OFFICE OF ENVIRONMENTAL SUSTAINABILITY

INSPECTOR'S REPORT ON AN APPLICATION FOR A CERTIFICATE OF AUTHORISATION FOR A CLOSED LANDFILL

TO:	Dr. Eimear Cotter, Director
FROM:	Ewa Babiarczyk, Inspector, Environmental Licensing Programme
DATE:	22 nd September 2020
RE:	Application by Roscommon County Council for a Certificate of Authorisation for a closed landfill at Cloondacarra Beg, Castlerea, County Roscommon .
	Certificate of Authorisation Register Number H0394-01.

Figure 3: Approximate extent of deposited waste and monitoring locations

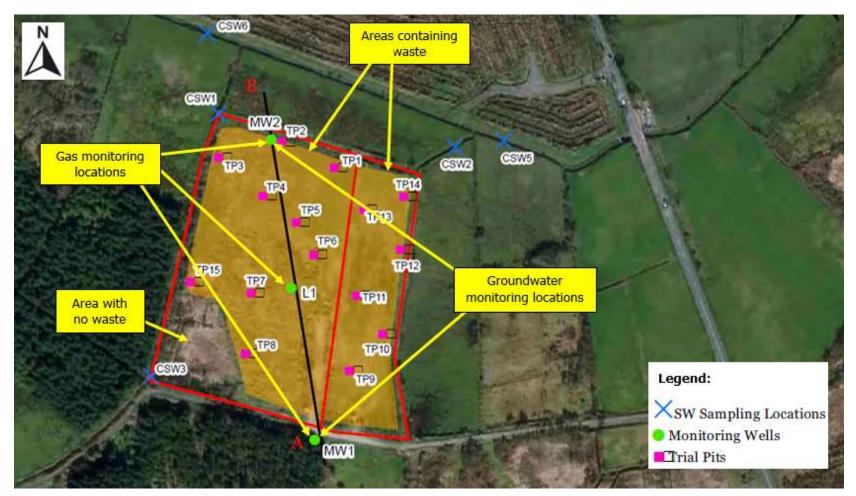
The surface water monitoring was carried out on 27th November 2017 and 8th August 2019 at five locations CSW1, CSW2, CSW3, CSW5 and CSW6, as shown in Figure 3.

The 2017 gas monitoring was carried out at three monitoring locations MW1, M2 and L1, as shown in Figure 3. The monitoring results show that methane concentrations varied from $3.7 $ %v/v in MW1 and $0.5 $ %v/v in MW2 to 76 %v/v at L1.
	In 2019, no methane was recorded at MW1 and the concentration of methane at MW2 was recorded at $1.8~\%$ v/v and no monitoring was carried out at L1.
	The monitoring results from March 2020 show that methane was recorded at 75.6 $\%$ v/v at L1, 0.1 $\%$ v/v at MW1 and 0.9 $\%$ v/v at MW2.
	'Landfill gas addendum' to the risk assessment states it is possible that the methane could originate from the peat subsoil locally. Considering however a very high methane generation at the monitoring location within the middle of the waste body and relatively low methane concentrations at MW1 and MW2, Condition 3.4 requires investigation of the source of such high methane levels. Furthermore, Condition 3.1(g) requires a gas pumping trial, while Condition 3.1(h) requires a report on the trial to be submitted to the Agency and agreement sought regarding any recommendations arising from the trial and their implementation.

Figure 5: Remediation infrastructure

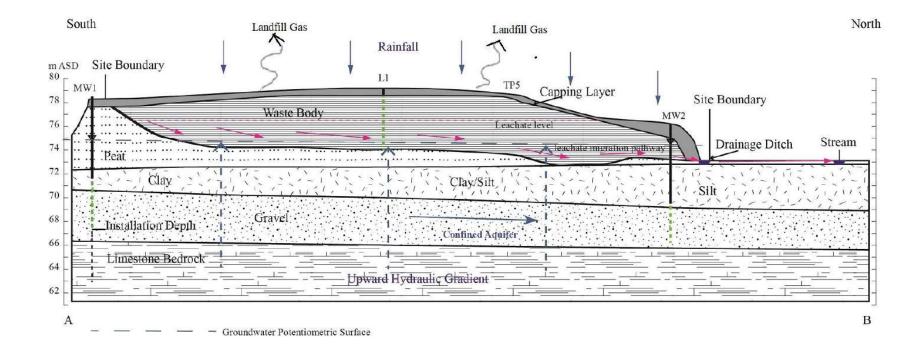
2. Perimeter berm
The risk assessment recommends installation of a compacted, low permeability clay perimeter berm around the waste body, as shown in Figure 5.

3. Gas ventilation wells
The risk assessment recommends that four gas ventilation wells, as shown in Figure 5, are installed to allow passive ventilation of landfill gas. The risk assessment further states that the well pipes should be 100mm slotted uPVC pipes and should extend 150mm above the top soil layer.
Condition 3.1(g) requires carrying out a gas pumping trial within six months. Additionally, having regard to the high methane concentrations recorded in monitoring well L1, Condition 3.4 requires investigation of the source of such high methane readings.
Having regard to the monitoring results submitted in support of the application for certificate of authorisation, the age of the closed landfill, the location of the nearest drinking water borehole (600m to the west-south-west of the site) and the fact that the nearby dwellings are serviced by public supply water mains, the following remedial measures are considered appropriate and recommended in Condition 3.1:

(a) Minimise the disturbance of deposited waste to the extent possible;
(b) Install a low permeability landfill cap, minimum 1m, with 1mm thick low permeability geomembrane having a hydraulic conductivity of less than or equal to 1x10 ⁻⁹ m/s;

(c) Install four gas vent pipes within the waste body. The gas venting pipes shall meet the following requirements:
(i) There shall be a fan on each gas venting pipe;
(ii) The gas vent pipes shall not be perforated above the ground level.
